WiMAX Forum Evaluation Group (WFEG) for IMT-Advanced Evaluation Progress Update

17 May 2010

Comments on IEEE's RIT Proposal

- Bandwidth of UL control channel in P802.16m/D5

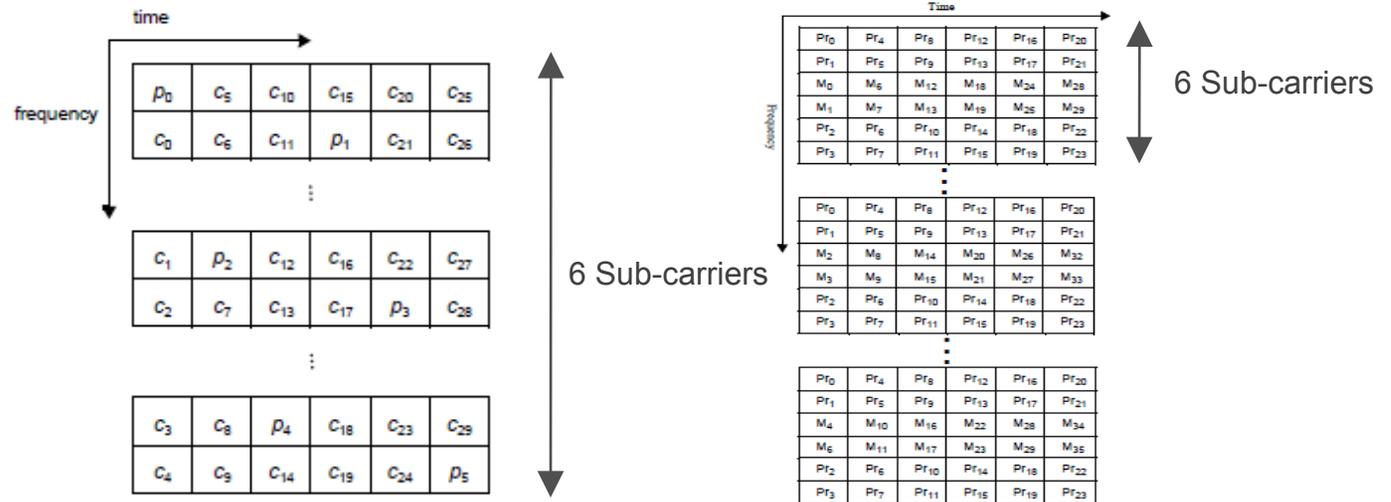
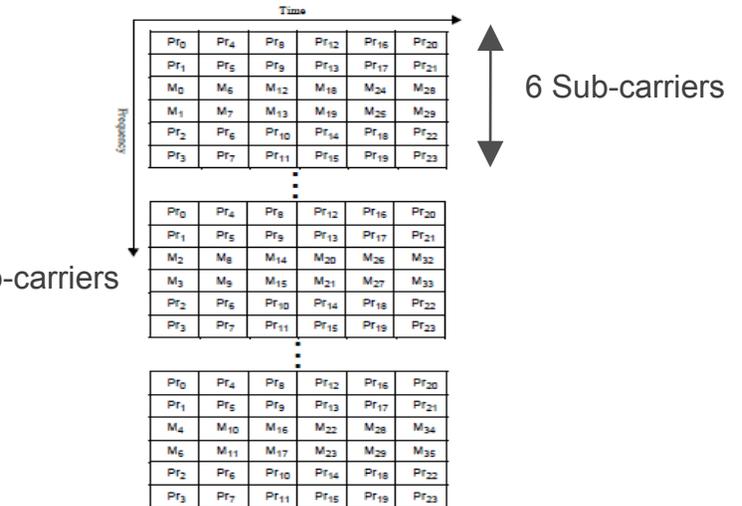
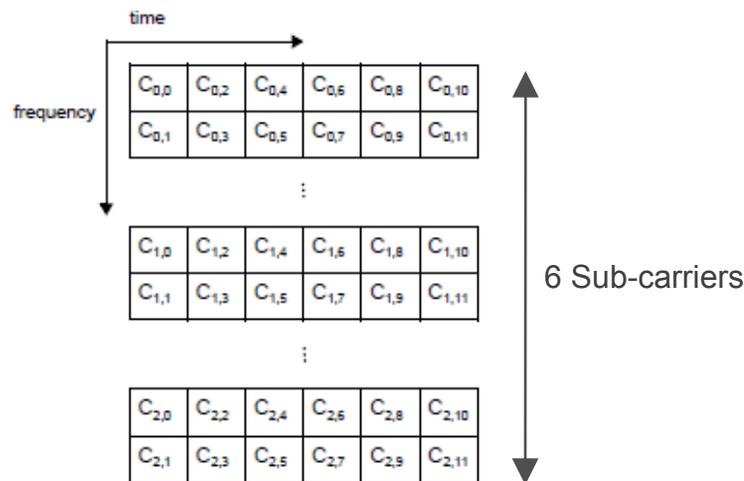
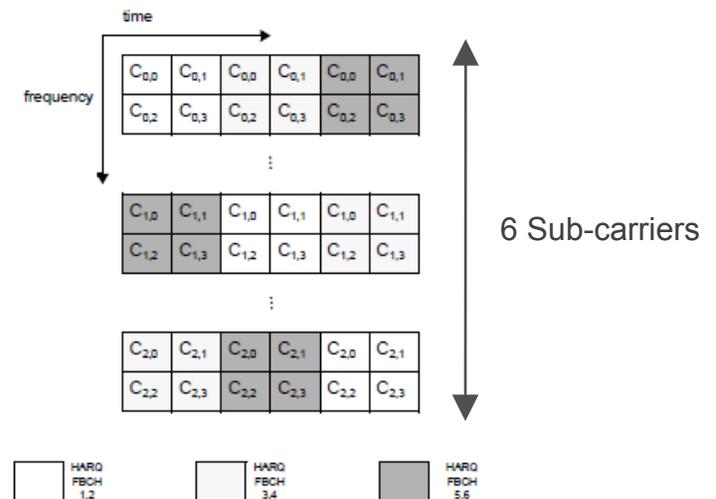
- No differentiation between the bandwidth of UL control channel and UL data channel

- According to IEEE's RIT proposal, the UL control channel (i.e. Ranging channel) will only occupy a portion of the bandwidth.
- The parameter in LBT does not reflect this characteristic, which will result in incorrect UL LBT calculation and worse UL coverage.

- Agree with IEEE's self-evaluation results. Suggest to further update the UL LBT to differentiate the channel bandwidth of UL control and UL data channel.
